August 30, 2018

Product Improvement Notice – Projection Welded Nut (Slide Head)

Lippert Components

Fig.1

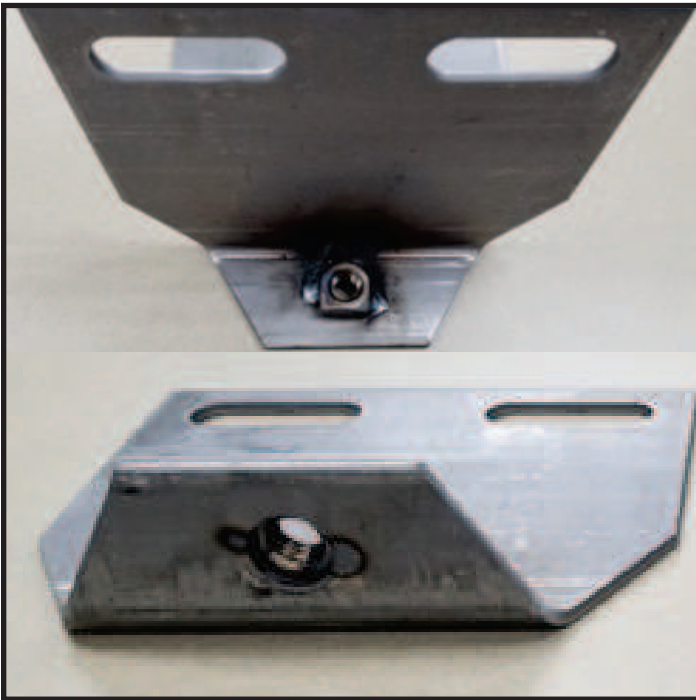
LCI is continuously looking for areas to improve processes and procedures. Recently, we reviewed our current procedure of fixturing and manually welding our slide-out heads. It was determined that there is room for human error and an improvement could be made. Our automation team developed a process to help improve consistency. We will be moving forward with projection welding the nut onto the slide head with our new automated system.

Fig. 1 depicts the square nut that is hand welded today and Fig. 2 is an example of the hex nut that is projection welded.

LCI performed physical testing by torquing the nut to 110 ft-lbs 10 times in succession without failure. This test was performed on 370 samples. On June 20th, 2018 we also implemented a weld scope to monitor all projection welds. If the weld does not reach the set current it will fail the part and put it in the reject bin. We also established standard protocol to replace the weld electrodes after every 4,000 pieces. When this number is reached, the machine will shut itself down and require the electrodes to be changed prior to continuing further production.
